RE: **PETITION NO. 1121** - Cellco Partnership d/b/a Verizon Wireless declaratory ruling that no Certificate of Environmental Compatibility and Public Need is required for the proposed replacement of and modifications to an existing telecommunications facility located at 353 Pumpkin Hill Road, Ashford, Connecticut. Request for Modification.

Petition No. 1121 Cellco Partnership d/b/a Verizon Wireless 353 Pumpkin Hill Road, Ashford Staff Report September 17, 2015

Figure 1. Site plan as approved on January 8, 2015.

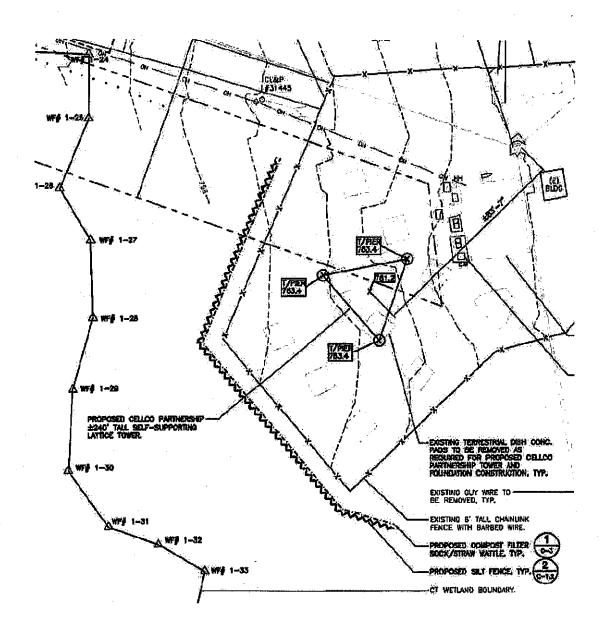
On September 10, 2015, All Points Technology Corporation (APT), on behalf of Cellco, submitted a modification to the site plan. Pre-construction discussions with Cellco's contractor for the referenced project revealed a need for a minor modification to the limit of work along the west side of the existing fenced compound. (See Figure 1) Providing a larger temporary construction staging/laydown area west of the existing compound would allow for improved construction vehicle access and staging in order to properly and safely construct the new tower and remove the guy anchors of the existing tower. In order to accommodate construction activities while providing proper protection to nearby wetlands, a revised limit of erosion control measures is proposed. The erosion control measures will shift approximately 49 feet west and no closer than approximately 11 feet of the wetland limits. (See Figure 2) The extent of this temporary construction staging/laydown area is intentionally limited to the existing cleared area to avoid removal of mature tree and shrub vegetation that currently buffers the wetland area.

- APT will meet the contractor on site to review the locations of wetland resources with emphasis on
 protecting these sensitive resources throughout the course of the construction project;
- APT will verify in the field with the contractor the proposed new limit of erosion controls to ensure no mature shrubs or trees are removed;
- APT will inspect the erosion controls following installation to ensure proper installation for protection of nearby wetland resources; and,
- The temporary construction staging/laydown area shall be restored by the contractor following construction by filling any ruts and seeding with New England Conservation Seed Mix.
